DEVELOPMENT REVIEW BOARD PANEL A AGENDA

2. [Resolution No. 409. Mercedes Benz Inventory Storage Area. The applicant is requesting approval of a Stage 2 Final Plan Modification and Site Design Review for site improvements to use an existing gravel building pad area for inventory storage on the south lot of the Mercedes Benz dealership.](#)

Exhibit A1
Staff Report
Wilsonville Planning Division
Mercedes-Benz Inventory Storage Area

Hearing Date:	November 14, 2022
Date of Report:	November 7, 2022
Application Nos.:	DB22-0005 Mercedes-Benz Inventory Storage Area - Stage 2 Final Plan Modification (STG222-0005) - Site Design Review (SDR22-0005)
Request/Summary:	The requests before the Development Review Board include a Stage 2 Final Plan Modification and Site Design Review for site improvements to use an existing gravel building pad area for inventory storage on the south lot of the Mercedes-Benz dealership at 25029 SW Parkway Avenue.
Location:	25029 SW Parkway Avenue. The property is specifically known as Tax Lots 600 and 700, Section 2AD, Township 3 South, Range 1 West, Willamette Meridian, City of Wilsonville, Washington County, Oregon.
Owner:	Swickard Auto Group (Contact: Eric Iverse

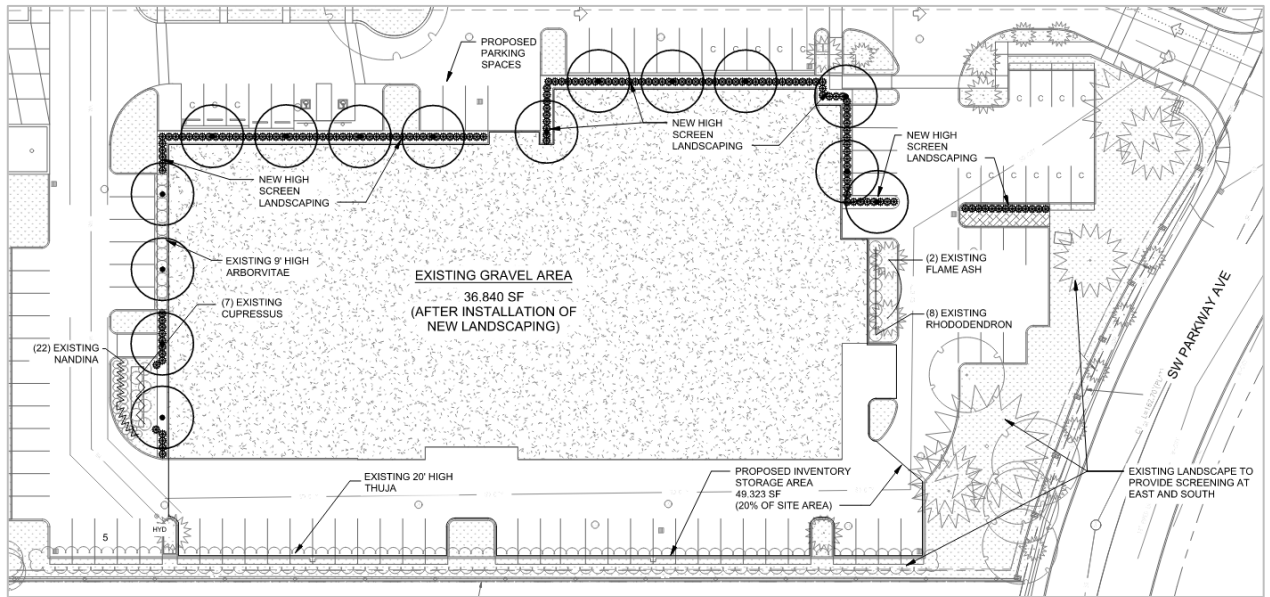
A49. As shown on the Proposed Stage 2 Landscape Plan (Exhibit B2), changes to site landscaping focus on required screening of the proposed inventory storage area on the south lot. No changes to landscaping are proposed in other areas of the site. .

The inventory storage area must be screened to the high screen landscaping standard. This standard requires sufficient high shrubs to form a continuous screen at least six (6) feet high and 95% opaque year-round. In addition, one (1) tree is required for every 30 linear feet of landscaped area, or as otherwise required to provide a tree canopy over the landscaped area. Ground cover plants must fully cover the remainder of the landscaped area. A six (6)-foot high masonry wall or a berm may be substituted for the shrubs, but the trees and ground cover plants are still required.

As shown in the illustration below, excerpted from the Proposed Stage 2 Landscape Plan, the applicant proposes Akebono Yoshino cherry trees planted approximately 30 feet on center on the west, north, and northeast sides of the inventory storage area. Emerald green arborvitae shrubs at least six (6) feet in height planted 32 inches on center are proposed between and under the trees to provide a continuous screen that is 95% opaque year-round. Massachusetts kinnikinnick groundcover is proposed in a small area of landscape island south of the employee parking area at the northeast corner of the inventory storage area. Existing landscaping provides the required screening on the southeast and south sides of the inventory storage area. The proposed landscaping, combined with some limited

- B15.** Perimeter trees in the applicant's Landscape Plan (Exhibit B2) are proposed to be 1.5-inch caliper (deciduous), which is not consistent with the 2-inch caliper requirement of this subsection. A Condition of Approval will require all trees to be a minimum of 2-inch caliper, balled and burlapped (B&B), well-branched, and typical of their type as described in Current American Association of Nurserymen (AAN) Standards.

STAGE II SITE PLAN

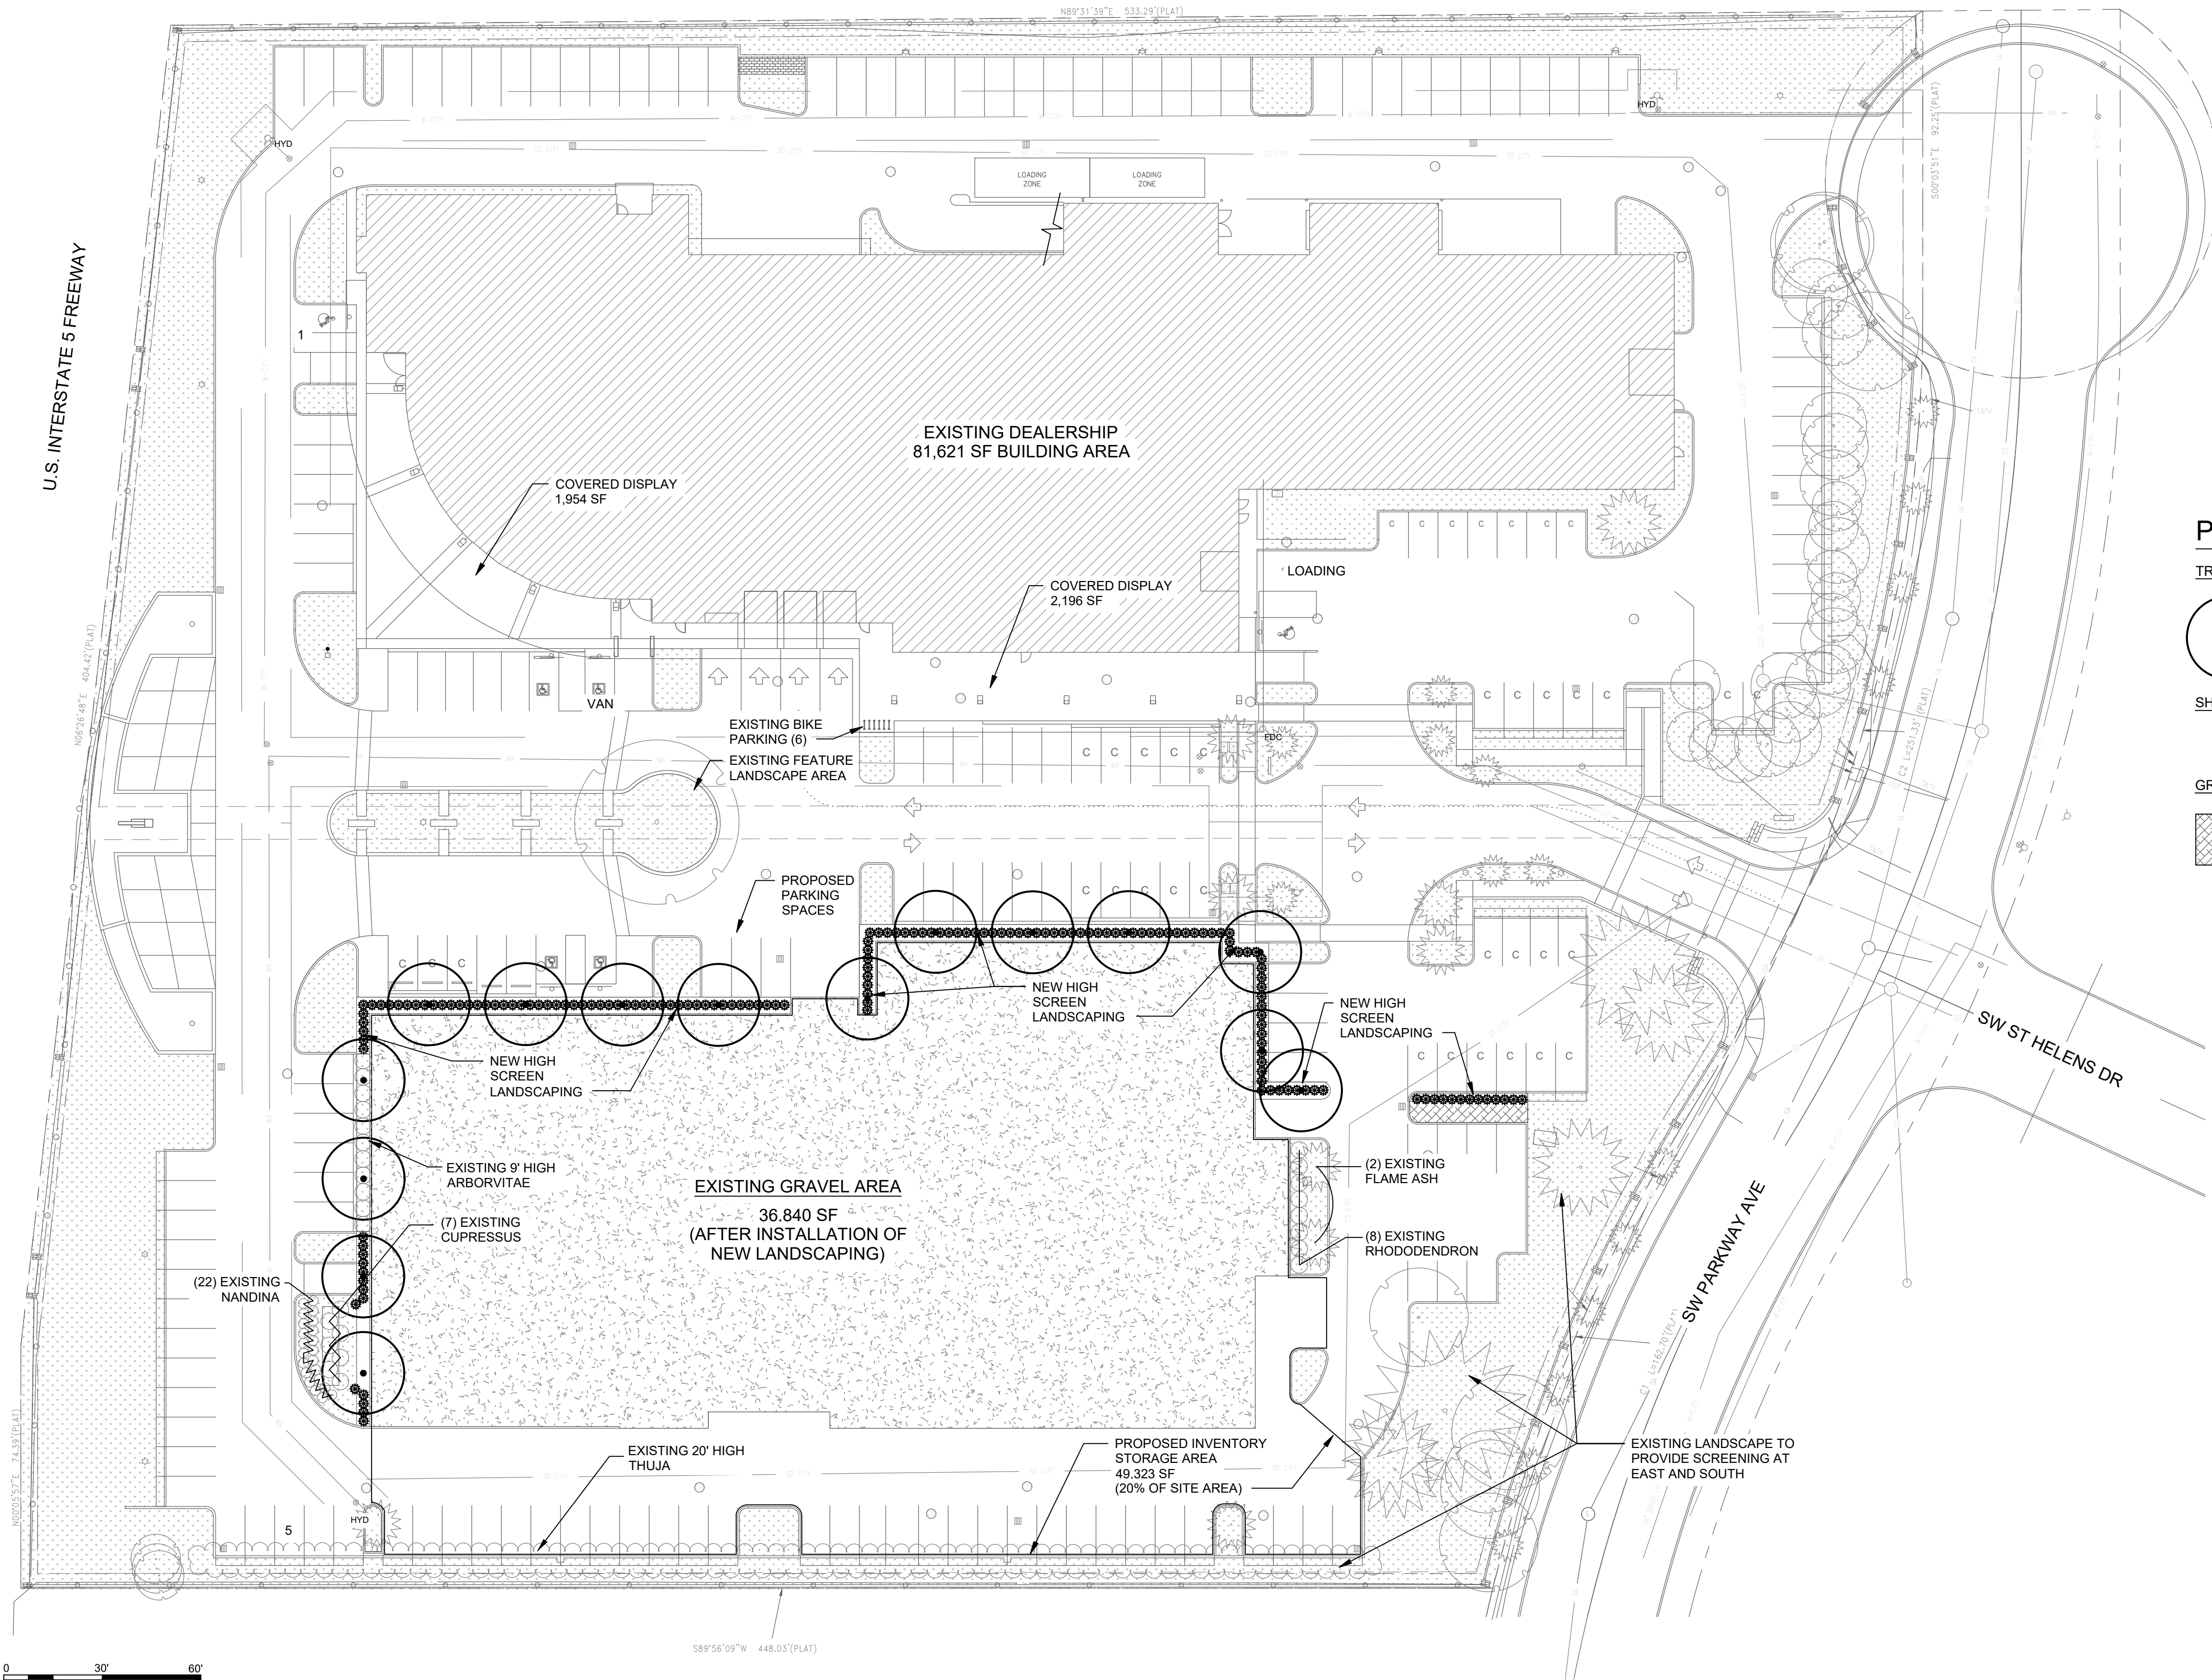
PREVIOUSLY APPROVED (DB9723)	38,560 SF
PROPOSED GRAVEL SITE AREA (THIS PLAN)	36,840 SF
DECREASE IN GRAVEL AREA	1,720 SF

NOTE: GRAVEL AREA HAS BEEN CHANGED TO PLANTING AREA, SO NO REAL NET INCREASE IN IMPERVIOUS AREA
